STATE OF ILLINOIS  
ENVIRONMENTAL PROTECTION AGENCY

NARRATIVE INSPECTION REPORT DOCUMENT

Date of Inspection: 3/28/90 Inspector: JAMES HAENNICKE  
Site Code: 0 3 1 6 0 0 0 0 3 4 County: COOK  
Site Name: LAND & LAKES #3 Time: 7:20-8:30 a.m.

Photo # 1 Roll # 90-293

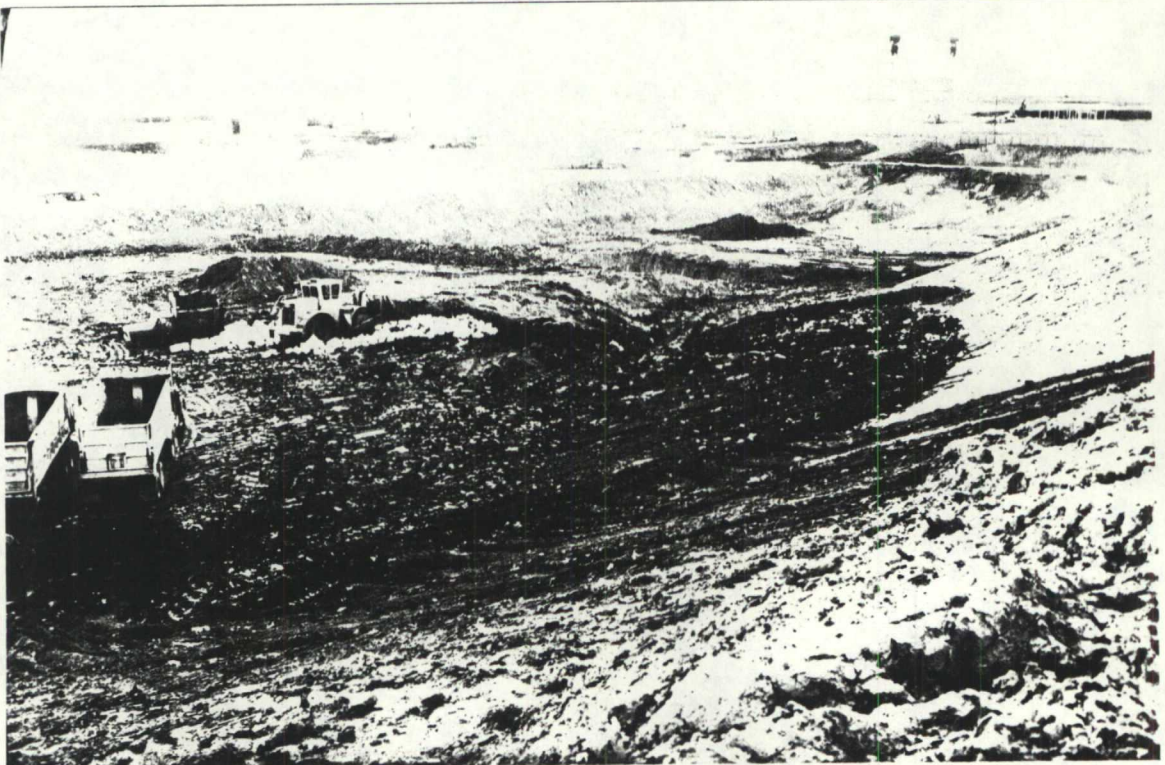
- LINE 5 Due to dry on-site roads, dust caused a notable problem as seen in photos 1 & 3. Mark stated that their water truck was inoperable and currently in the on-site maintenance shop.
- LINE 26 Photo 6 depicts a small stream of leachate emanating from the road in the filled western portion of Land & Lakes. Mark asked if covering the area with clay, as in past practices, would be sufficient. I reminded him that this would only be a temporary solution. My suggestion was to include a leachate collecting concrete culvert in addition to the clay. When asked if the leachate pumped from the culvert could be deposited with the daily refuse in the active area I told Mark to transfer it instead to their wastewater pond. Here it could be permanently treated so as not to pose any problems in the future.
- LINE 27 Water truck inoperable.

Comments: EAST

ACTIVE AREA; DUST

I met with Bob and Mark at 9:00 a.m. on 3/30/90, for a follow-up inspection. The leachate problem was remedied by the above mentioned actions. Also, in regard to their dust violation, Land & Lakes 3 has on site a spare water truck from their maintenance garage on 134th street.

Photo # 3 Roll # 90-293

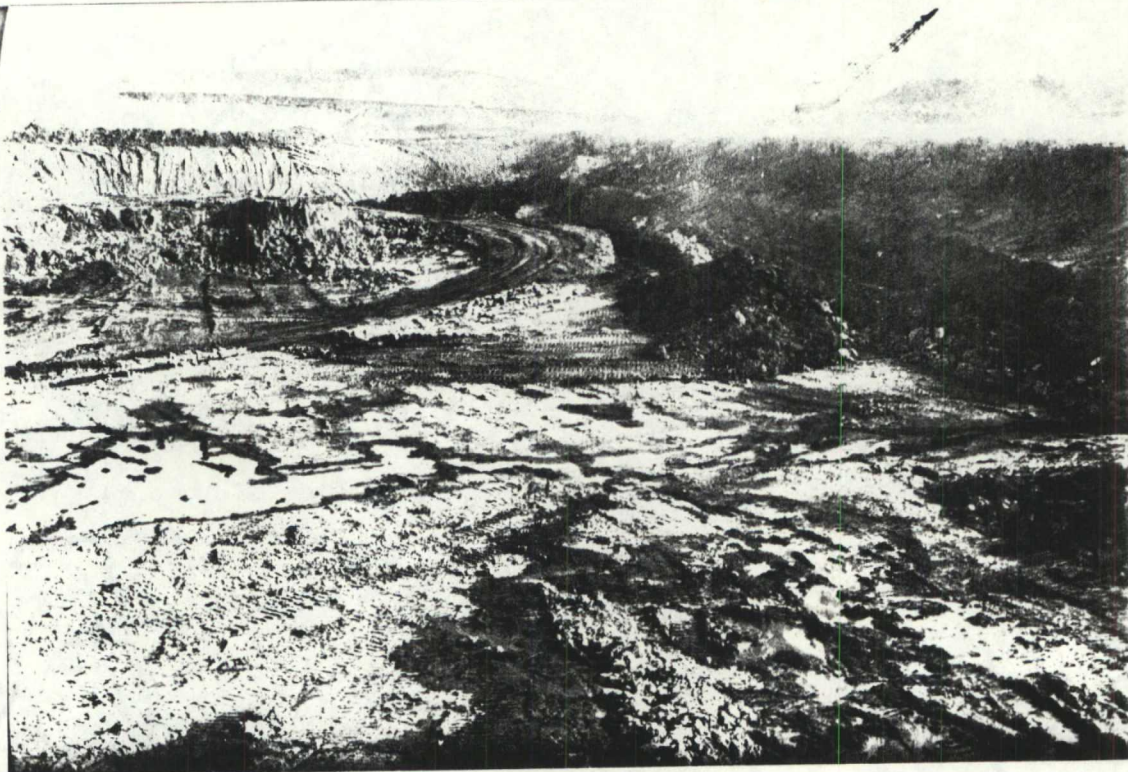
Comments: NORTH

EXCAVATION PIT; DUST

Photo # 6 Roll # 90-293

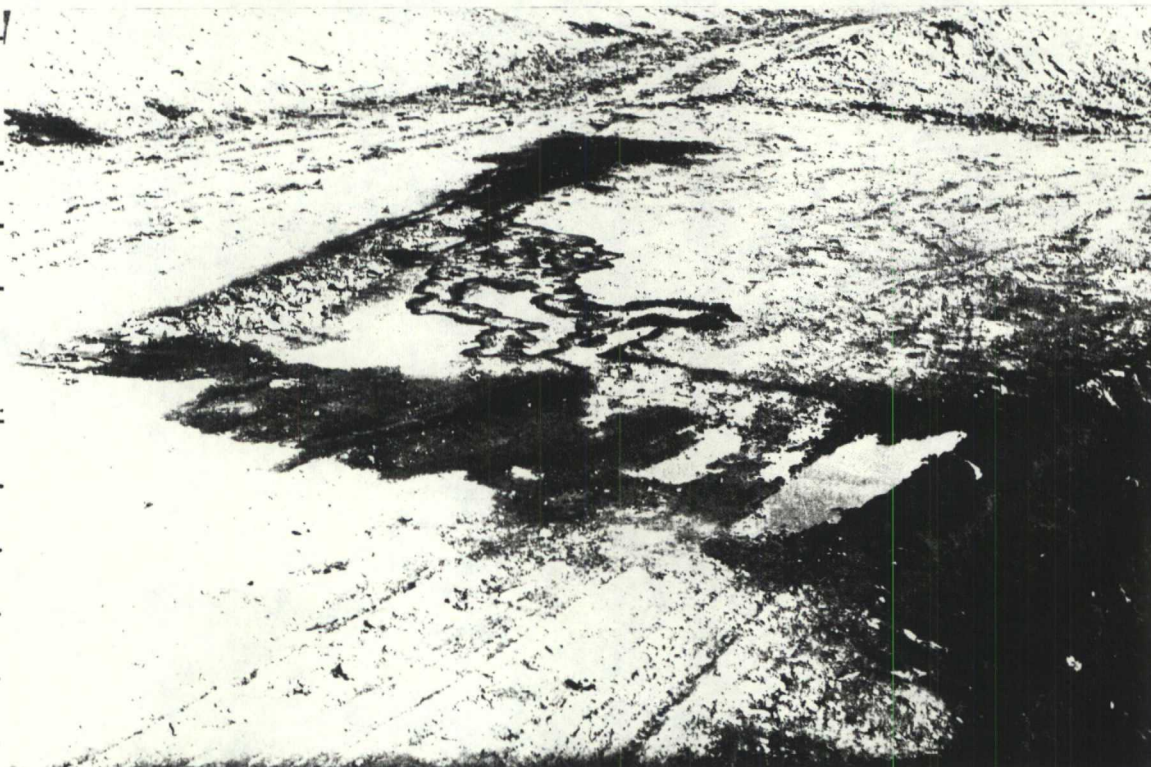
Comments: NORTH

LEACHATE STREAM

Land & Lakes superintendent Bob Kras called me shortly after the inspection stating that clay was applied to the area where leachate was present and that a concrete culvert was being installed. He asked if I would come out and verify that compliance was being initiated.
